February 9, 2018

In Reply Refer To: HSST-1/B-300

• J-J Hooks® MASH Free-Standing Barrier

Name of system: J-J Hooks® MASH Free-Standing Barrier

Figure 5.7. Summary of Results for MASH Test 3-10 on J-J Hooks<sup>®</sup> Free-Standing PCB.

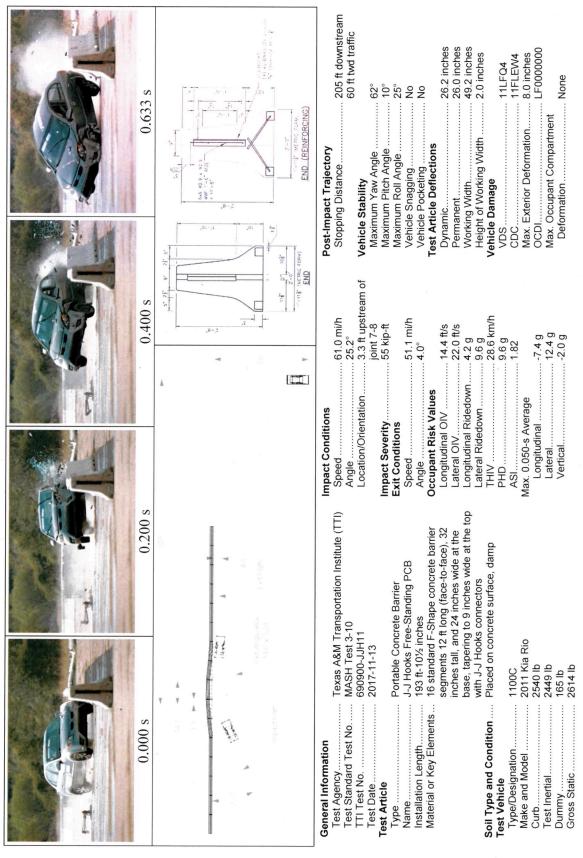
Page 3 of 5
Required Test Number	Narrative Description	Evaluation Results
3-10 (1100C)	A 2011 Kia Rio, traveling at a speed of 61.0 mi/h, contacted the J-J Hooks® MASH Free-Standing PCB 3.3 ft upstream of a joint between barrier segments at an impact angle of 25.2°. The barrier contained and redirected the 1100C vehicle. The vehicle did not penetrate, underride, or override the installation. The working width was 49.2 inches at a height of 2.0 inches near the toe of the barrier. Maximum dynamic deflection of the barrier during the test was 26.2 inches, and maximum permanent deformation was 26.0 inches. No vehicle occupant compartment deformation or intrusion was noted. The 1100C vehicle remained upright during and after the collision event. Maximum roll and pitch angles were 25° and 10°, respectively. Maximum longitudinal OIV was 14.4 ft/s, and maximum lateral OIV was 14.4 ft/s, and maximum lateral OIV was 22.0 ft/s. Maximum longitudinal occupant ridedown acceleration was 4.2 g, and maximum lateral occupant ridedown acceleration was 9.6 g.  The J-J Hooks® Free-Standing PCB performed acceptably for MASH Test 3-10 for longitudinal barriers. Crash test report 690900-JJH11 is attached for this test.	PASS

Figure 5.9. Summary of Results for MASH Test 3-11 on Easi-Set MASH Free-Standing Barrier.

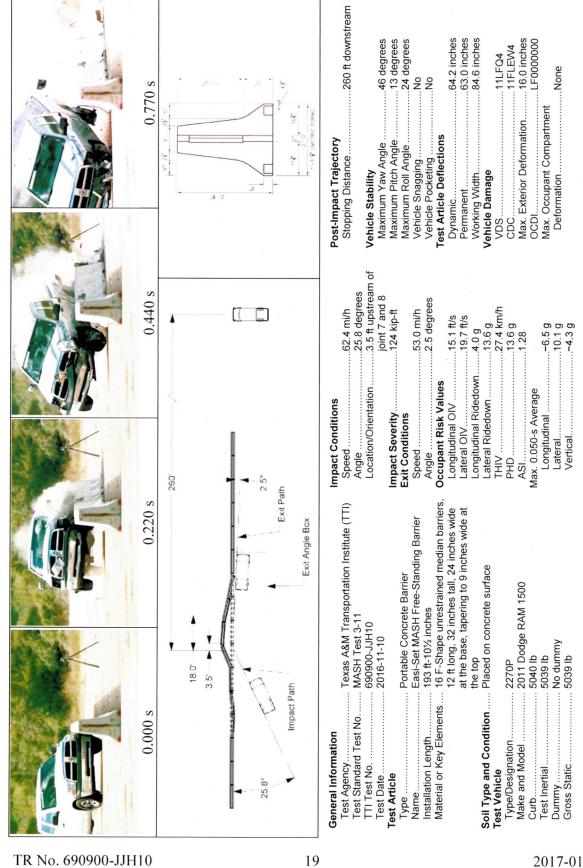
Page 4 of 5
Required Test Number	Narrative Description	Evaluation Results
3-11 (2270P)	A 2011 Dodge RAM 1500 pickup truck, traveling at a speed of 62.4 mi/h, impacted the J-J Hooks® MASH Free-Standing Barrier 3.5 ft upstream of the joint between barrier segments, at an impact angle of 25.8 degrees. The J-J Hooks® MASH Free-Standing Barrier contained and redirected the 2270P vehicle. The vehicle did not penetrate, underride, or override the installation. Maximum dynamic deflection during the test was 64.2 inches. Only small pieces of the concrete spalled off the installation; however, these pieces did not penetrate or show potential to penetrate the occupant compartment, nor present hazard to others in the area. No occupant compartment deformation or intrusion occurred. The 2270P vehicle remained stable during and after the collision event. Maximum roll and pitch angles were 24 degrees and 13 degrees, respectively. Longitudinal OIV was 15.1 ft/s, and lateral OIV was 19.7 ft/s. Maximum longitudinal ridedown acceleration was 4.0 g, and maximum lateral ridedown acceleration was 13.6 g.  The J-J Hooks® MASH Free-Standing Barrier performed acceptably for MASH Test 3-11. Crash test report 690900-JJH10 is attached for this test.	PASS
